From: James OPOLONY <james.opolony@lafargeholcim.com>
Sent: Monday, January 13, 2020 2:56 PM
To: Barria, German; Alyssa Makridakis
Cc: Peter Kossis; Sprague, Jeff; Bernoteit, Bob
Subject: Re: [External] Re: Holcim (US), Inc. - ID #031600FHQ
Attachments: 5 03-22-2019 - Figures.pptx

Loading from Surge Bin (P15A/P21) to Main Distribution Silo (P23) Controlled by Dust Collector (DC01) Venting to Stack S10;

Title:
 Fugitive Dust Plan

FIGURE 2
PROCESS BLOCK FLOW DIAGRAM
FESOP CONFIGURATION with SLAG PILES UPDATED

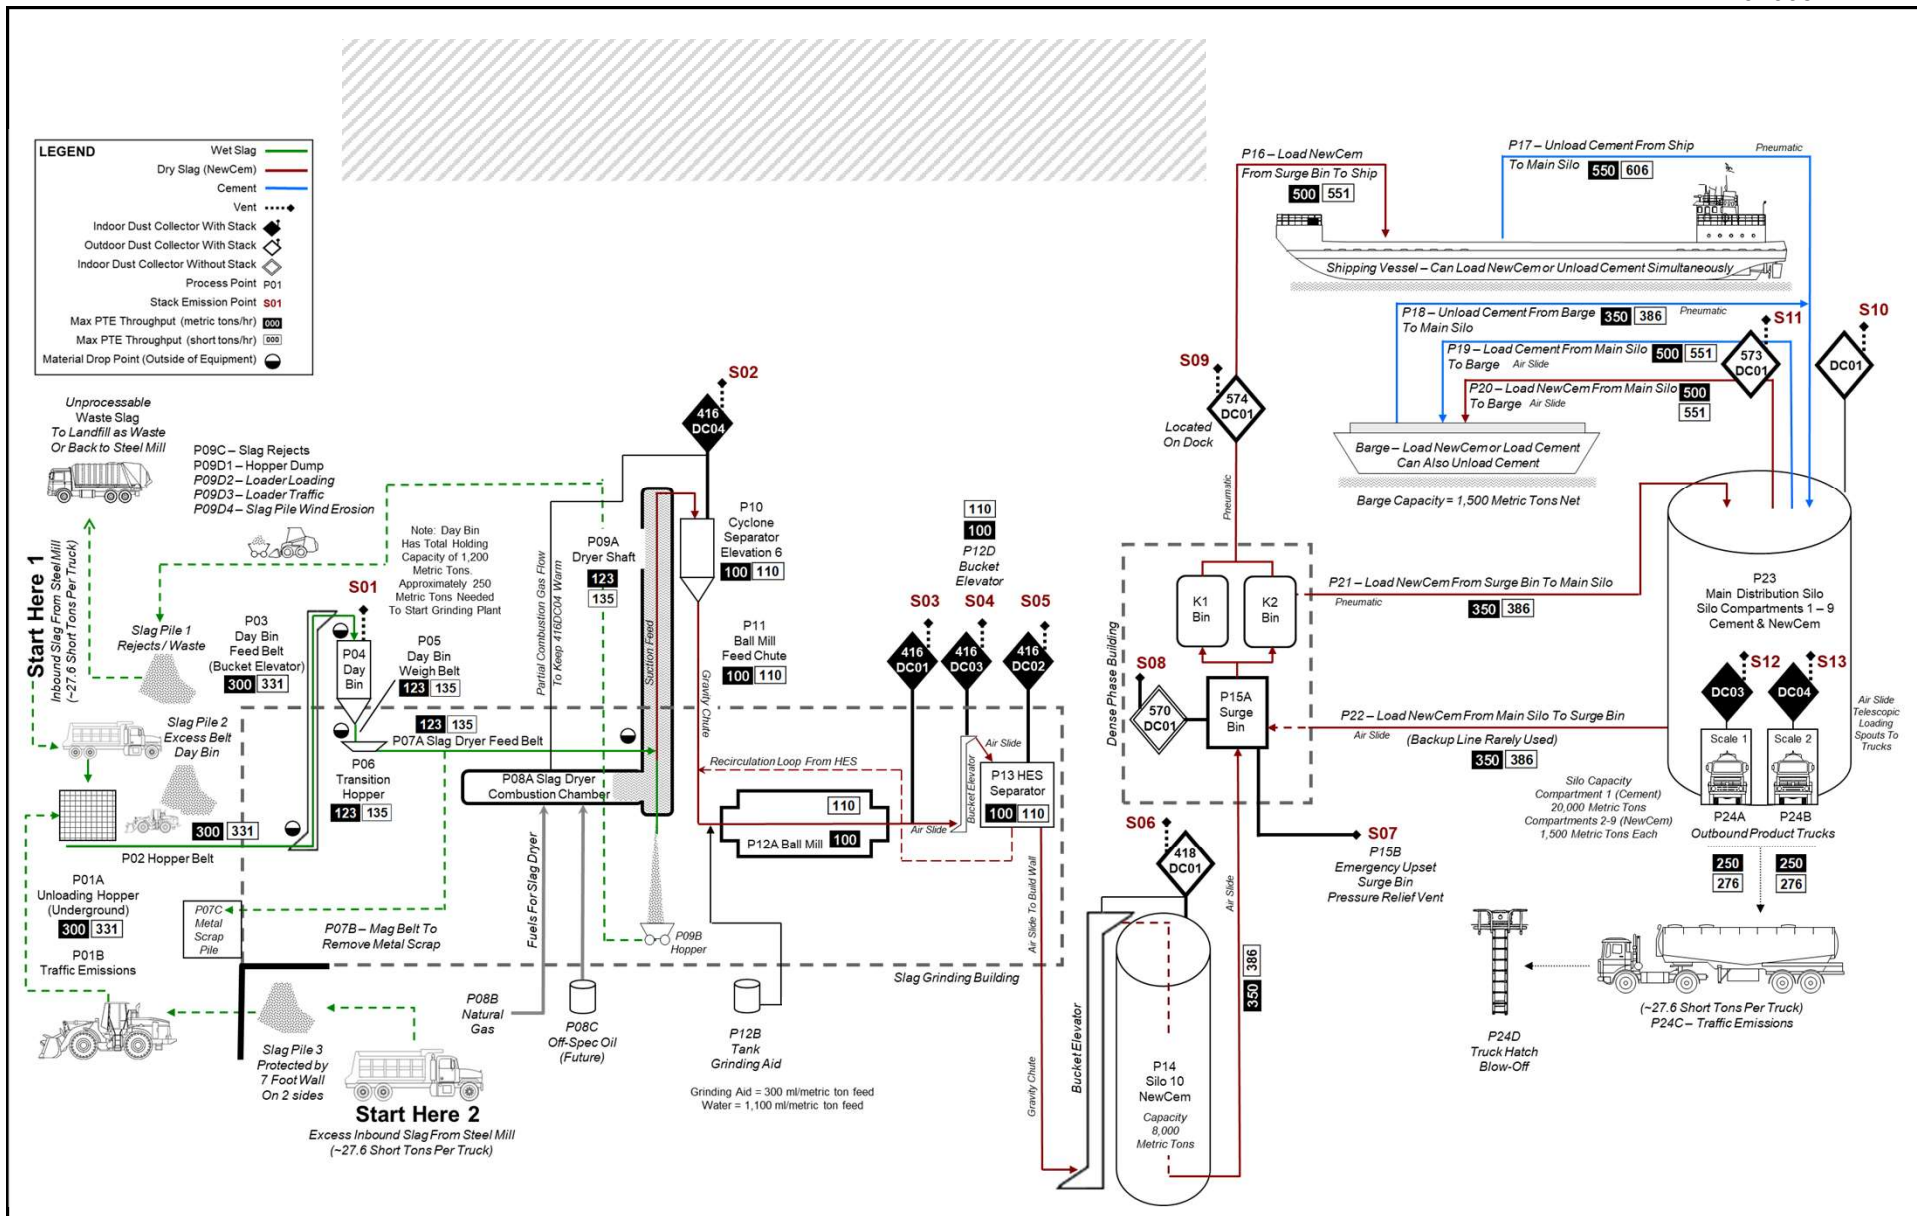
It seems that there is a continuous flow of venting P01A to P02 to P03 to P04 and finally venting to stack 01, we would like you to provide us with a diagram, stack dimensions, and images of how that arrangement looks like.

The pictures were good, viewable, we still are uncertain about how the process of moving the NewCem (slag) from Surge Bin (P15A) through Bins (K1 & K2) to Main Silo (P23) and Loading NewCem to barge and shipping Vessels, as to where the emission points are, and are they dust collectors with exhaust screens or are there actual vents. It appears that DC01 has three pick-up points (570/S08, 573/S11, 574/S09, & top of P23 /S10).

IT was not so clear from the pictures to see where DC01 exhaust. The diagram indicates that it is located in the duck, but it appears that there is also an exhaust stack on the top of Main distribution Silo P23.

I've attached some pictures, as well as the diagrams we submitted with our Fugitive Dust Plan, that I think will be helpful. P01-P04 is the process of moving the wet granulated slag from the truck into the storage silo we refer to as the Day Bin. There is no "stack" on the silo in the traditional sense, but small access doors do allow for some venting (this is referred to as a vent on the diagram provided). The material does indeed flow continuously until it arrives in the Day Bin, as you said.

The second emission unit you've inquired about refers to the system we use to transfer the finished cement. Once the wet granules are dried and ground in the mill process, the material ends in Silo 10 (P14). From here, the material moves via air slide into the surge bin (P15A) and then into the pipe (P21) running to the distribution silo (P23). The dust collector on this silo (DC01) has a small rectangular exhaust fan, listed as S10. This can be seen on slides 2 and 4 of the attached presentation.

The surge bin directs material into one of the two bins while the other offloads. Everything is moved pneumatically, so while one bin is loading, the other is offloading. The material from these bins can be directed to either the main silo or shipping vessels. Barges are loaded out of the main silo, primarily via gravity. There is a dust collector in the dense phase building near the surge bin and the K1 & K2 bins (what we call kettles), as shown on the diagrams I provided.

The only dust collectors with traditional "stacks" are in the mill building, and the stacks are visible in the provided picture. DC01 on the main silo has a small, screened exhaust vent approximately 2' by 2' in size. This vent is located on the top of the silo, but due to inclement weather I was unable to a closer picture. 570/S08 is located in the dense phase building, and operates separately from DC01 on top of the main silo. 573/S11 is also separate, and is located near the dock by the barge loading equipment (see point 7 on slide 5 of the provided presentation). 574/S09 is separate as well, and can be see at point 8 on slide 5 of the presentation. DC01/S10 does provide dust collection for any material loaded into the main silo, either from the K1/K2 bins or from the vessels (P17).
